This is to certify that Thayer Matthew F & /Preservation Timber Flooring Inc.  
has permission to Structural Enhancements/Future Living Space 3rd floor  
AT 62 Munjoy St 016 B011001

**City of Portland, Maine - Building or Use Permit**

<b>Proposed Use:</b> Single Family	<b>Proposed Project Description:</b> Structural Enhancements/Future Living Space 3rd Floor
---------------------------------------	---

<b>To:</b> Tammy Munson	<b>From:</b> Matt Thayer
<b>Fax:</b> 874-8716	<b>Date:</b> 2/7/03
<b>Phone:</b> 874-8706	<b>Pages:</b> 3 (incl. cover)
<b>Re:</b> Floor Plans	<b>CC:</b>
62 Munjoy St., Ptd

# THIRD FLOOR PLAN VIEW

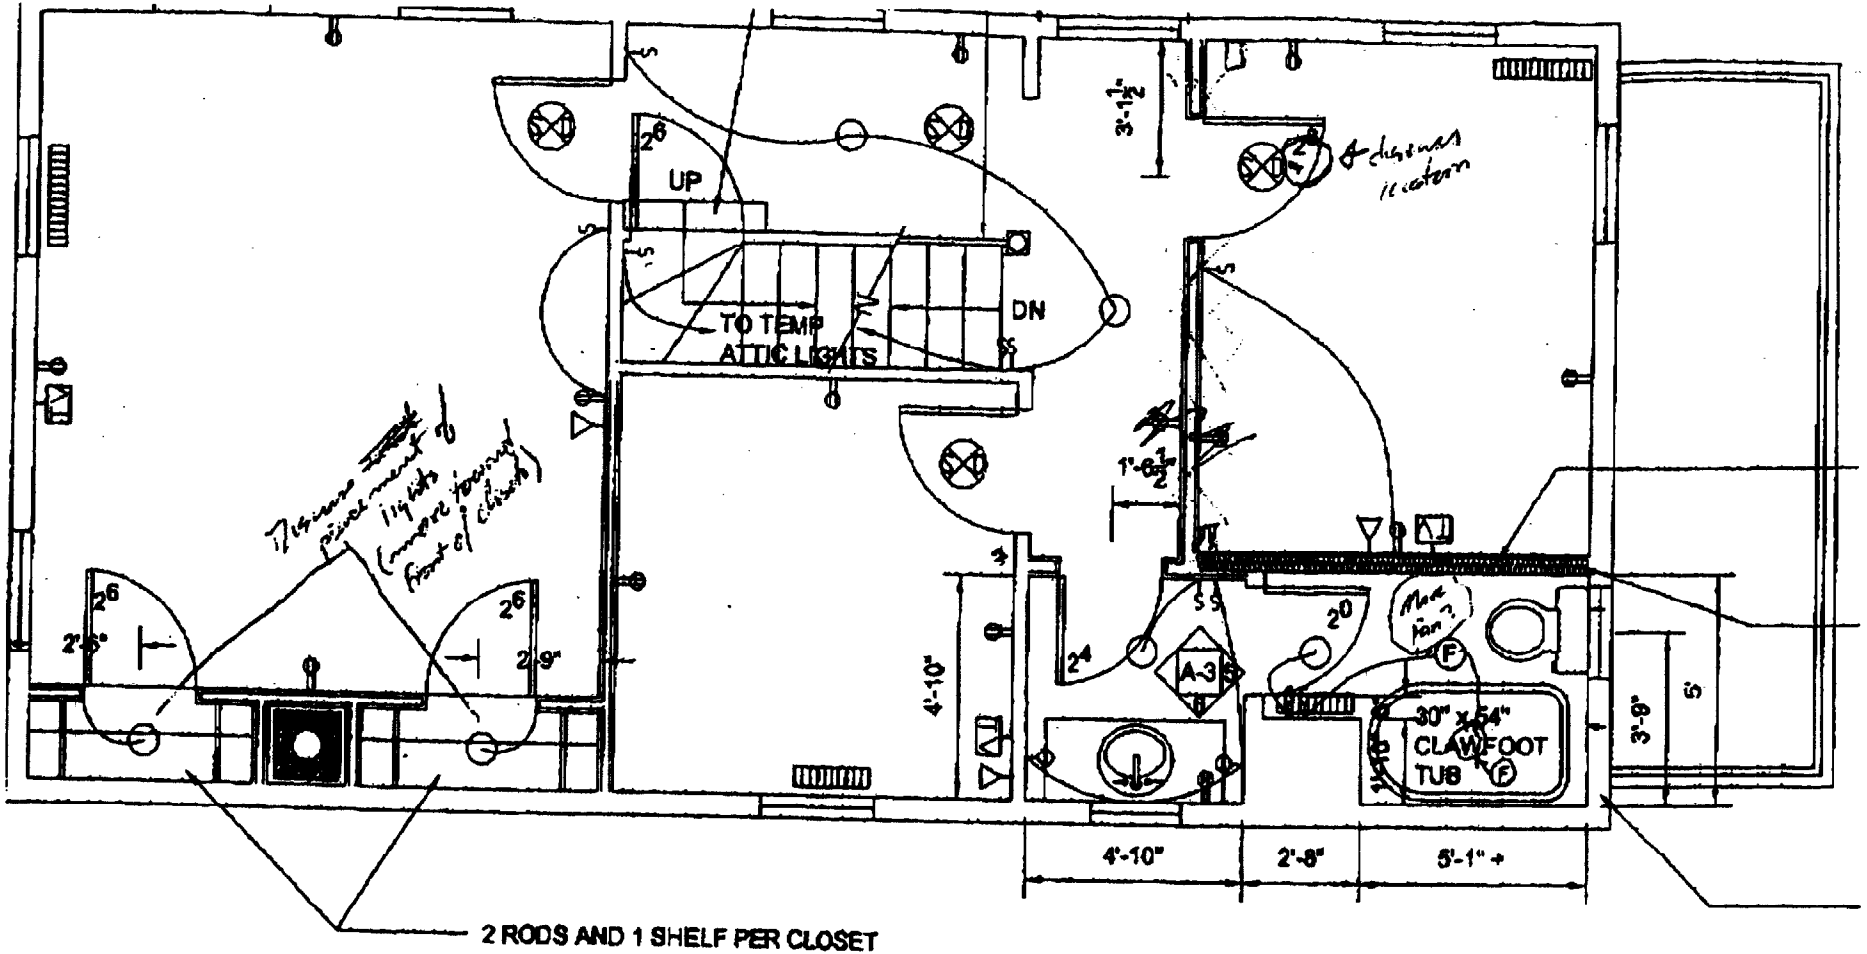
<b>Comments:</b> 2/7/03-tm: need floor plan and need to know if it is a bedroom egress windows are needed
--

I've attached a floor plan showing future layout of the 3<sup>rd</sup> floor, as well as a copy of the 2<sup>nd</sup> floor floor plan showing the stairs to the 3<sup>rd</sup> floor, per your request. As I mentioned earlier, the 3<sup>rd</sup> floor was finished by previous owners as living space, but we've decided, after consulting an engineer, that it would make sense to enhance the floor joists up there to bring it up to code, even though previous owners don't appear to have had problems with it.
